Application for Amendment

Application under the *Agricultural Operation Practices Act* to amend a permit for a confined feeding operation, manure collection area and/or manure storage facility(ies). ("Permit" means an NRCB-issued or grandfathered approval, registration, or authorization, including a grandfathered municipal development permit.)

NRCB USE ONLY <input checked="" type="checkbox"/> Approval <input type="checkbox"/> Registration <input type="checkbox"/> Authorization	NRCB Application number LA24002XA	Date Stamp NRCB APPLICATION RECEIVED 31 JAN 25
---	--	--

Which permit do you wish to amend? (List permit number and issuing agency.)	AO Comment: Applicant is applying to amend NRCB Approval LA24002X. LA 24002 N.R.C.B
Legal Land Description(s)	SE 21-09-26 W4 <small>(Qtr-Sec-Twp-Rg-W Mer)</small>

**FEED LOT LAYOUT
PROPOSED PLAN & DETAILS**

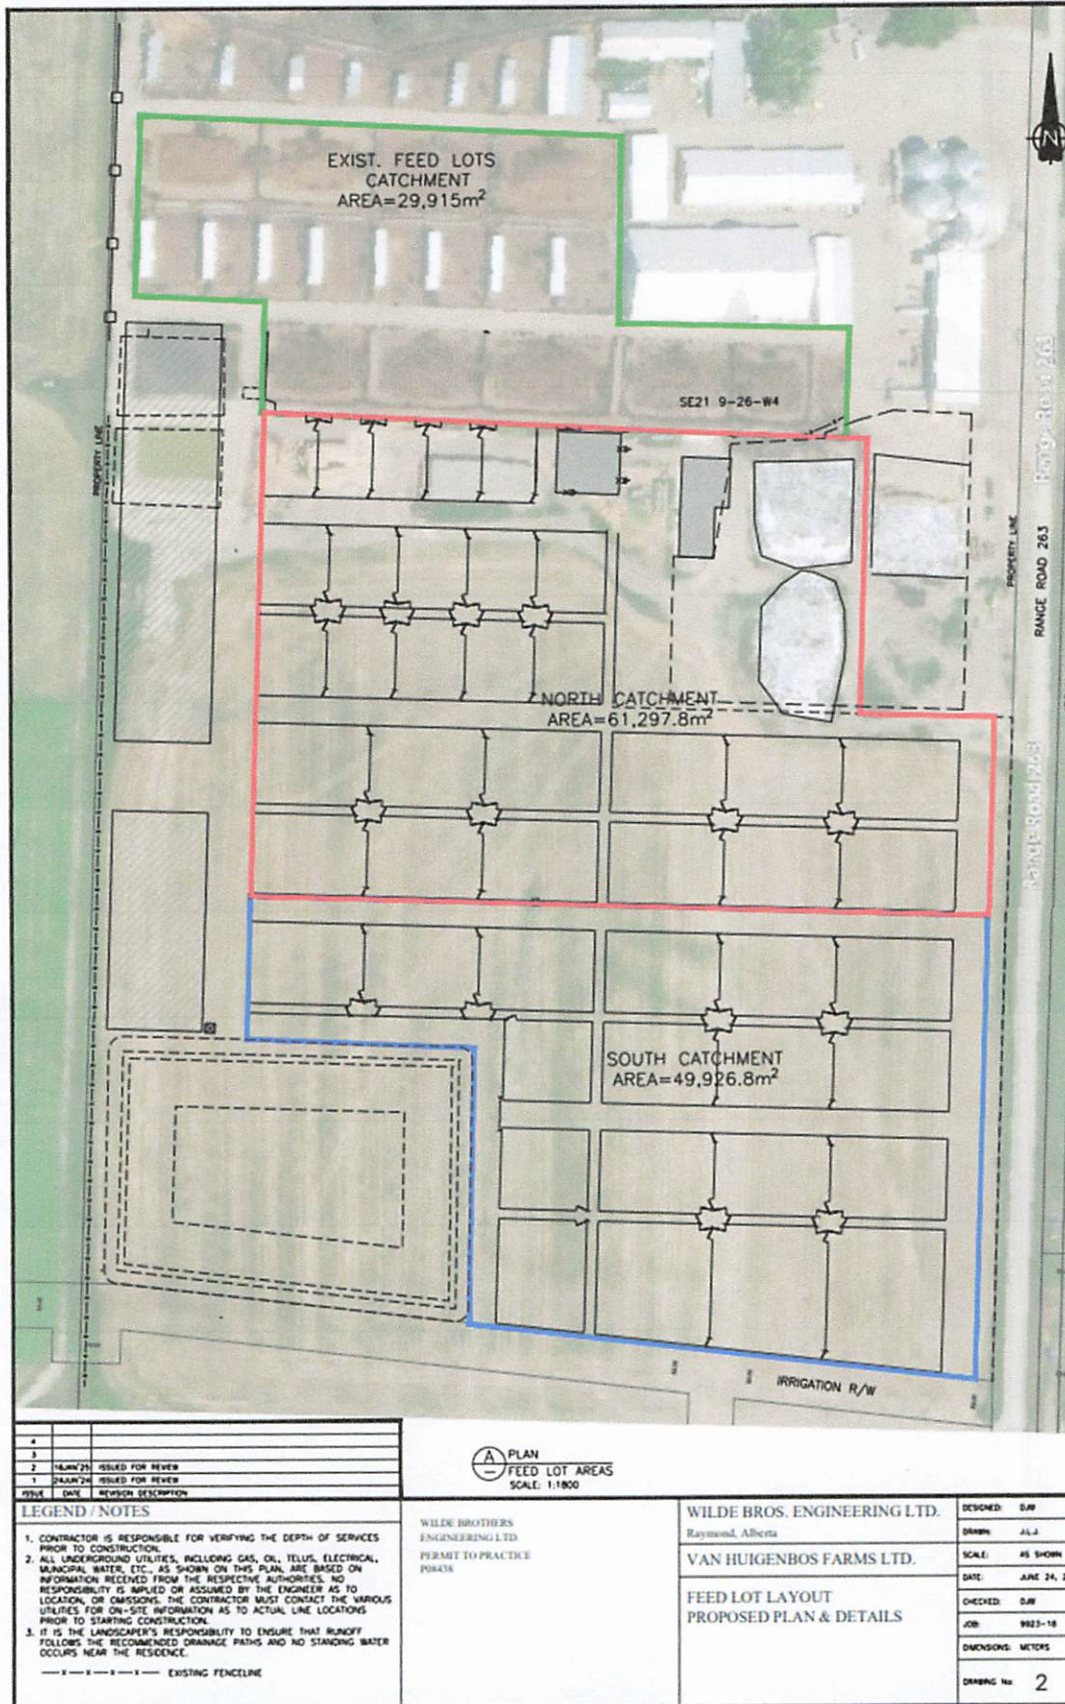
AO Comment: Applicant is applying to amend the dimensions of the following facilities:

North Catch Basin to the as built dimensions of 185 m x 42 m x 2.25 m deep (average). The permitted dimensions in LA24002X were 185 m x 40 m x 2 m deep. Applicant indicated that the depth of the catch basin slopes from 2 m deep in the north portion to 2.5 m deep in the south portion, to allow for easier emptying and removal of solids.

South Catch basin to the as built dimensions of 96 m x 42 m x 2.25 m deep (average). The permitted dimensions in LA24002X were 105 m x 40 m x 2 m deep. Applicant indicated that the depth of the catch basin slopes from 2 m deep in the south portion to 2.5 m deep in the north portion, to allow for easier emptying and removal of solids.

West pens to dimensions 152.1 m x 35.7 m (5 rows), 38.8 m x 35.7 m (2 rows), and 38.8 m x 45.9 m, irregular shape (1 row). The permitted dimensions in LA24002X were 152.1 m x 36.9 m (6 rows) and 50.7 m x 36.9 m (2 rows).

East pens to dimensions 152.8 m x 35.7 m (5 rows) and 152.8 m x 62.5 m, irregular shape (1 row). The permitted dimensions in LA24002X were 153.4 m x 36.9 m (6 rows).

Catch Basin Dimension Calculator

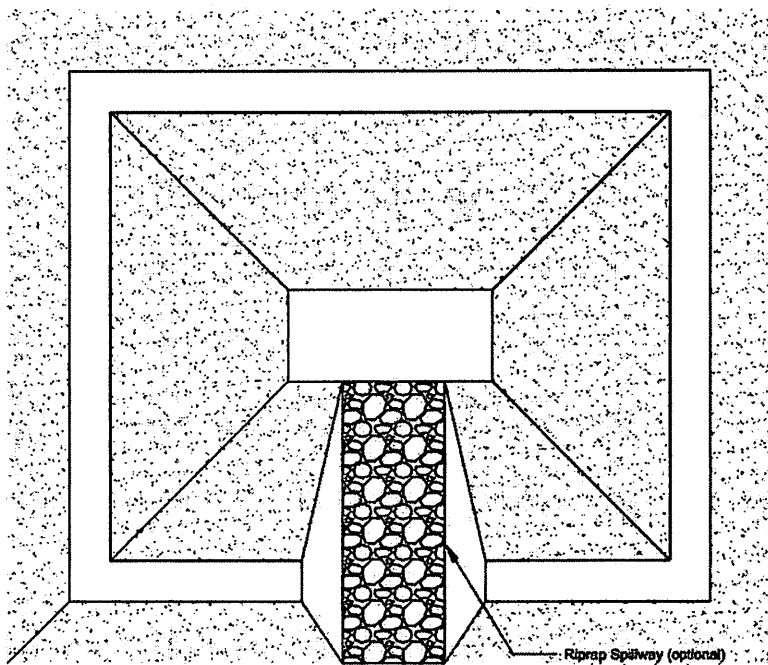
Construction Dimensions	Storage Dimensions
Length (m): 96	93.0
Width (m): 42	39.0
Depth (m): 2.5	2

Runoff potential:	4491 m ³
Catch basin volume:	5766 m ³

The catch basin dimensions meet the design requirements in AOPA
